Product Change Notification: PCN-23-173100

micro sim connector, mini sim connector,

**SIM card Date Code change
because of shell plating plant
location change**

SIM card Date Code change point on shell

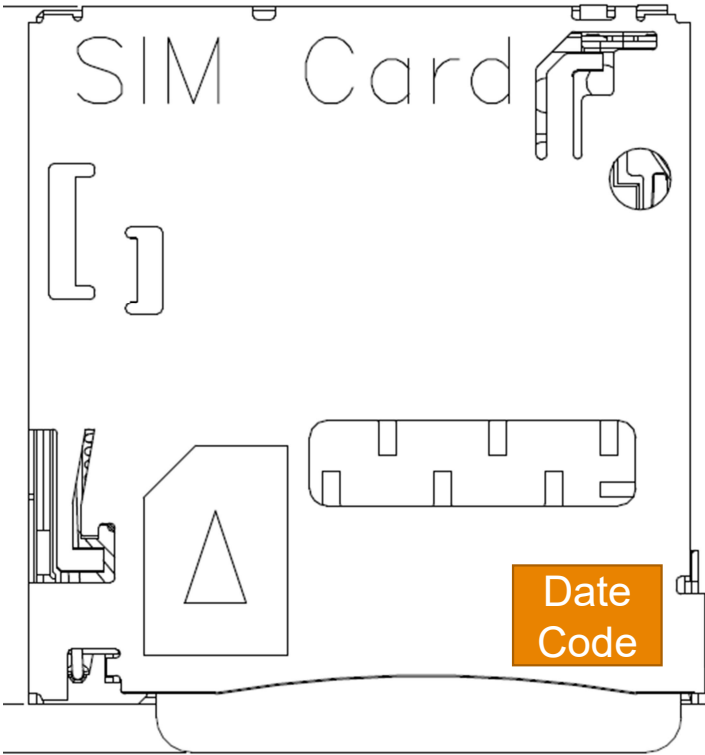
shell change manufacturing to new plating plant location. Along with that, the laser DC mark are changed of shell. please refer to attachment for detail. the change does not effect any Function.

Current plating Date Code

new plating Date Code
